U.S. DEPARTMENT OF AGRICULTURE
FOREST SERVICE

SHELTER, FIRE

This amendment forms part of Forest Service Specification 5100-320G, dated June 1998.

**5100-320G
Amendment 3**

663-Rev-Da
03-09-01

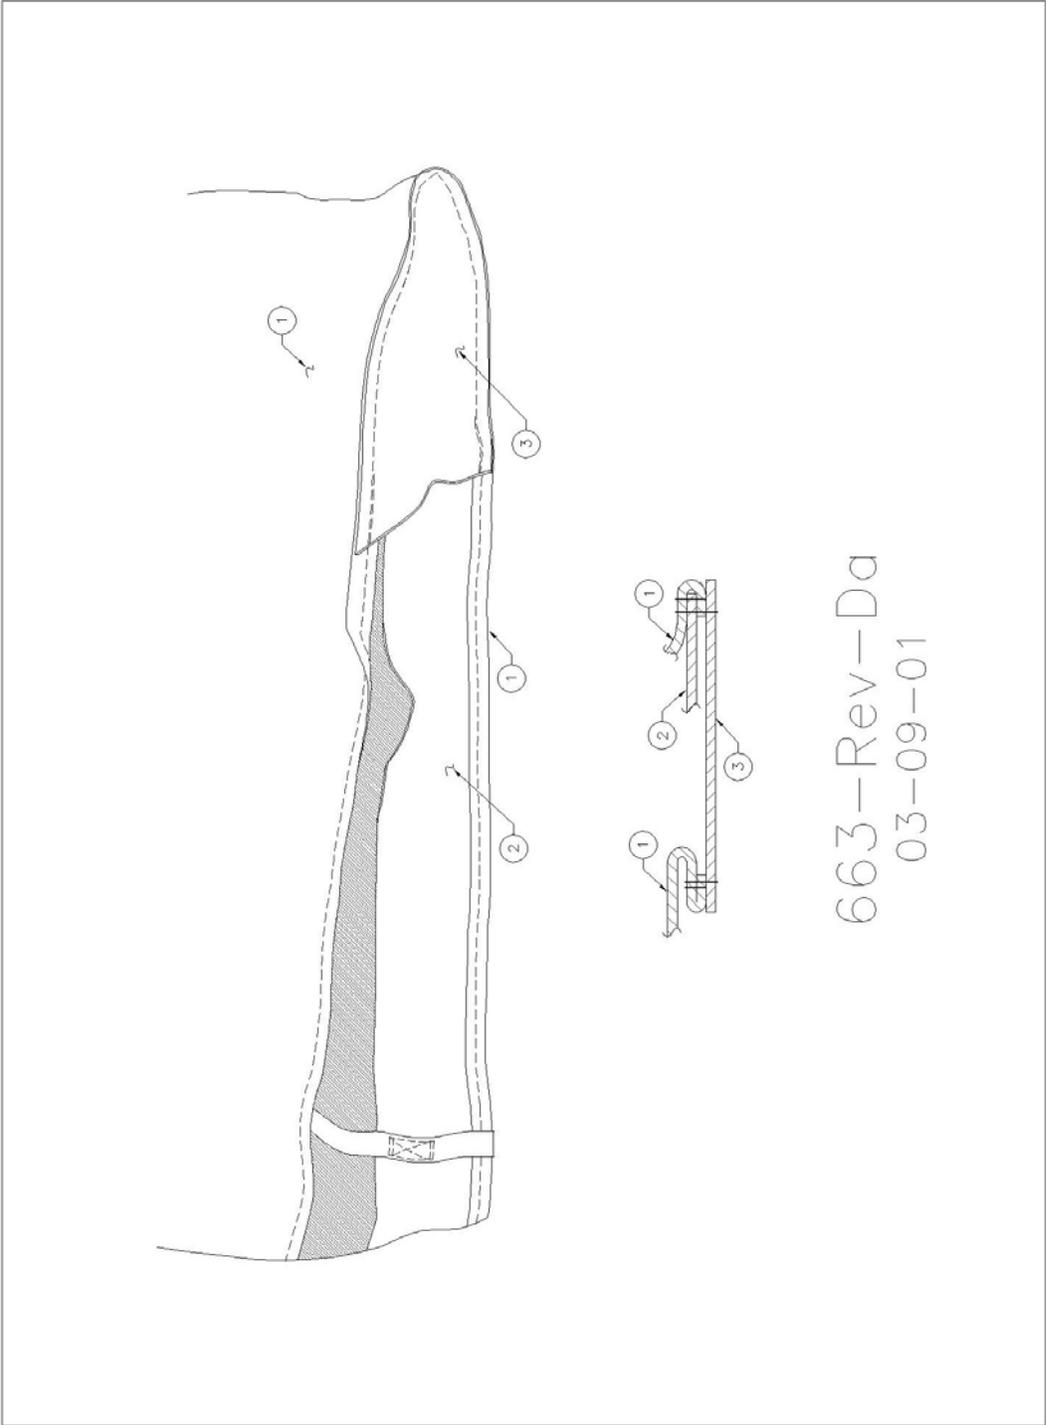
"663-Rev-Da-Model" (attached) shall be added as clarification to the corner construction of Drawing MTDC-663D, sheet 1.
